UNITED STATES PATENT AND TRADEMARK OFFICE

APPLICATION NO.	FILING DATE	FIRST NAMED INVENTOR	ATTORNEY DOCKET NO.	CONFIRMATION NO.
10/781,177	02/18/2004	Rafail Zubok	SPINE 3.0-455 CIP CONT I	1815
530 7590 01/30/2007 LERNER, DAVID, LITTENBERG, KRUMHOLZ & MENTLIK 600 SOUTH AVENUE WEST WESTFIELD, NJ 07090			EXAMINER WOODALL, NICHOLAS W	
			ART UNIT 3733	PAPER NUMBER
SHORTENED STATUTORY PERIOD OF RESPONSE		MAIL DATE	DELIVERY MODE	
3 MONTHS		01/30/2007	PAPER

Office Action Summary

DETAILED ACTION

Figure 1

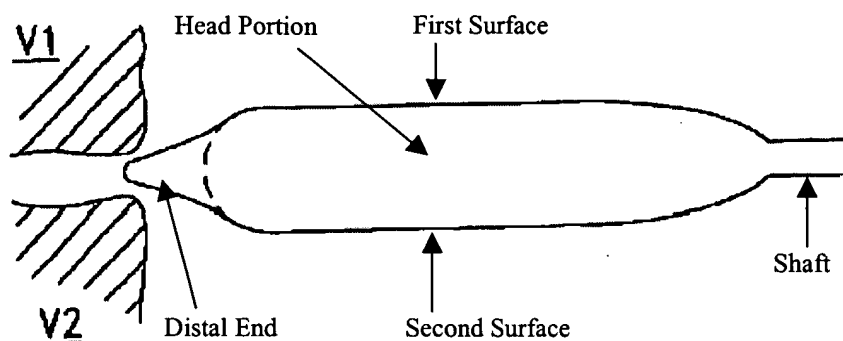
Regarding priority for claims 1-20, the examiner believes the claims are supported in application 10/688,632 filed on 10/17/2003, but the claims are not supported in application 10/382,702 filed on 03/06/2003. Therefore, for examination the claims will have a priority date of 10/17/2003. Regarding claim 1, Foley discloses a device comprising a shaft that includes a handle and a head disposed at a distal end of the shaft. The head includes a first surface and a second surface that are spaced apart by a distance (see Figure 1 below). Regarding claim 2, Foley discloses a device wherein the first surface has a generally oval footprint area and the second surface also includes an area. Regarding claim 3, Foley discloses a device wherein at least one of the first surface includes a substantially convex area or the second surface includes a substantially flat area. Regarding claim 4, Foley discloses a device wherein at least one of the first surface is tapered towards the distal end or the second surface is tapered towards the distal end. Regarding claim 10, Foley discloses a set of devices wherein

each device comprises a shaft having a handle at a proximal end and a head disposed at a distal end of the shaft. The head includes a first surface and a second surface that are spaced apart. Foley further discloses the set of devices have head portions that differ in size (column 18 lines 42-55). Regarding claims 11 and 12, Foley discloses a set of devices wherein the heads of the devices differ in thickness by about 1 mm (column 7 lines 3-7). Regarding claim, Foley discloses a set of devices wherein a square area of the head portions is different between the devices. Since Foley discloses a set of devices that have different thickness the devices also have a square area that is different. Regarding claim 15, Foley discloses a set of device further including one or more disc replacement devices (column 18 lines 42-55). Regarding claim 16, Foley discloses a method of using a device as discussed above comprising the steps of inserting a first trial into one of the intervertebral disc spaces to facilitate at least some distraction of the vertebral bones in a direction along a longitudinal axis and inserting a second trial into the intervertebral disc space to facilitate at least some further distraction of the vertebral bones along the longitudinal axis, where the second trial has a larger head thickness, measured substantially from the first surface to the second surface, than that of the first trial (column 19 lines 22-33). Regarding claims 17-20, Foley discloses a device that can be inherently used by a method as discussed above further including the steps of levering the handle of at least one of the first and second trials to facilitate the distraction of the vertebral bones (claim 17), repeating the insertion of further trials having a larger and larger head thickness to facilitate the distraction of the vertebral bones to a target distance (claim 18), wherein the target distance is one

that substantially maximizes the intervertebral space while substantially preserving an annulus and ligaments associated with the vertebral bones (claim 19), and inserting an intervertebral disc replacement device into the intervertebral space after it has been distracted to the target distance.
